FEDERAL COMMUNICATIONS COMMISSION
445 12th STREET SW
WASHINGTON DC 20554

Re: M & M Broadcasters, Ltd.
KLRK(AM), Mexia, Texas
Facility Identification Number: 21493
File Number: BP-20100514ABJ

This is in reference to the referenced application (File Number: BP-20100514ABJ) of M & M Broadcasters, Ltd ("M & M"), the licensee of radio station KRLK(AM), Mexia, Texas (the "Application"). The Application proposes to the move KRLK(AM)'s transmitter site (29 kilometers), increase its day power (from 500 watts to 2.5 kilowatts), reduce its nighttime power (from 128 watts to 72 watts) and change its daytime and nighttime antenna system (from nondirectional to directional). An initial review of the Application reveals several deficiencies and discrepancies, which M & M must correct before the staff can complete the processing of the Application.

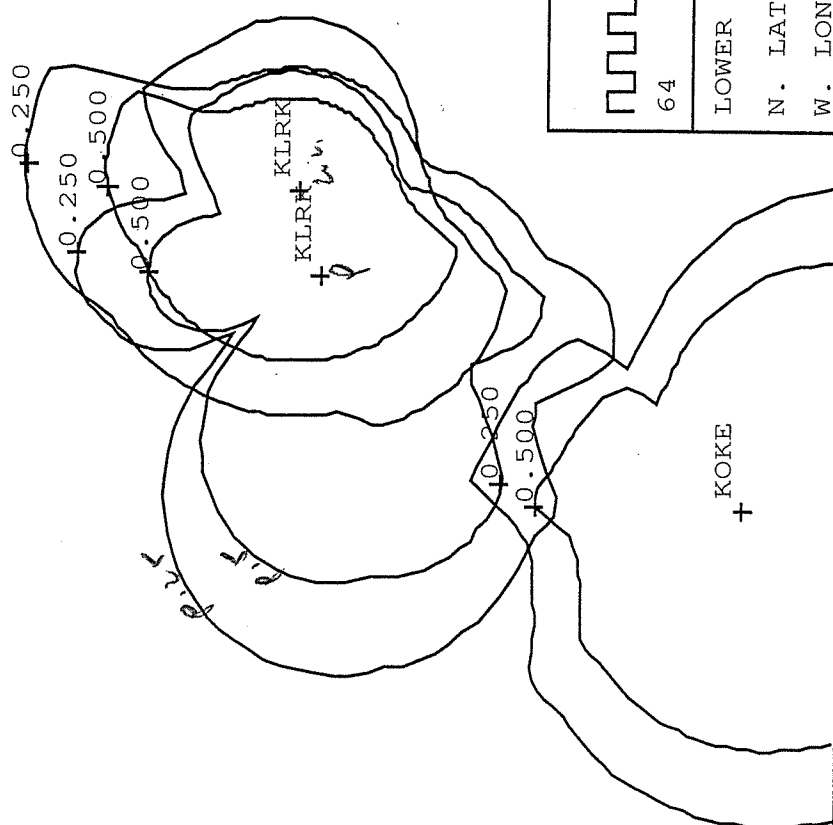
no more but
acceptable
M-3

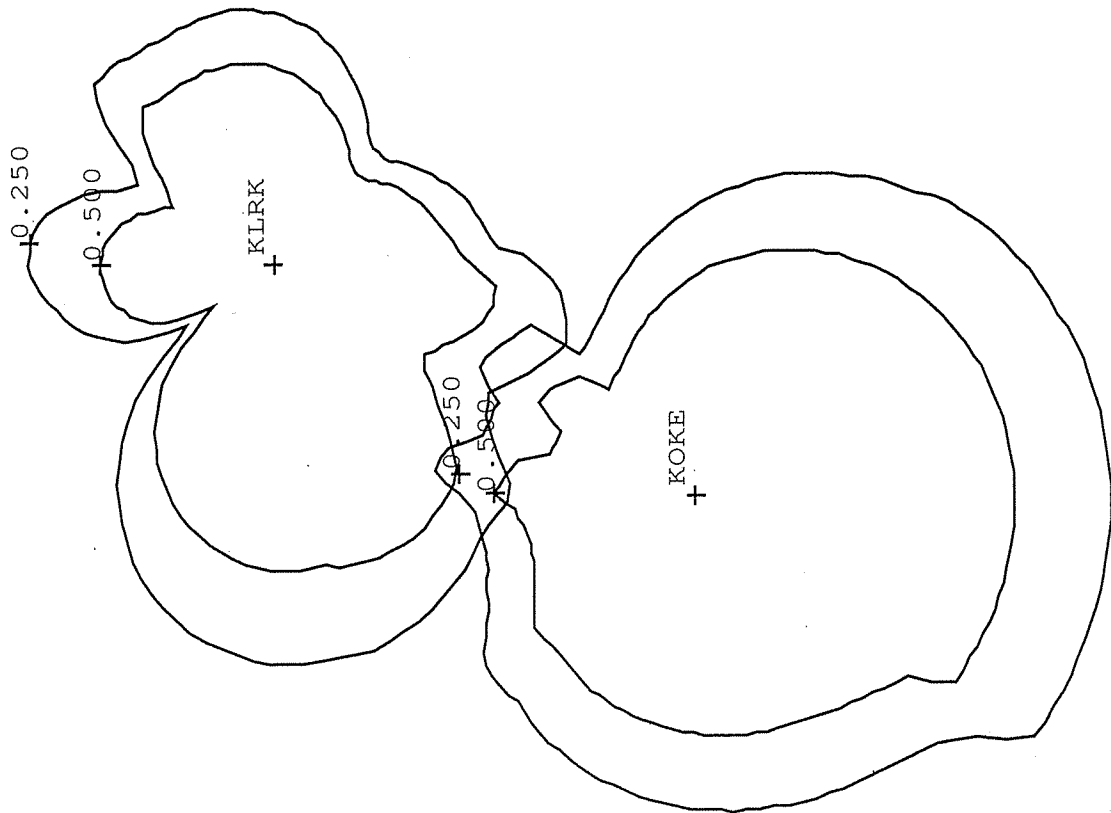
³ Had the KOKE(AM) measurement data been accepted, the proposed contours still caused prohibited contour overlap to KOKE(AM) and KLRK(AM).

with measurements

new overlap
with measurements
mms.
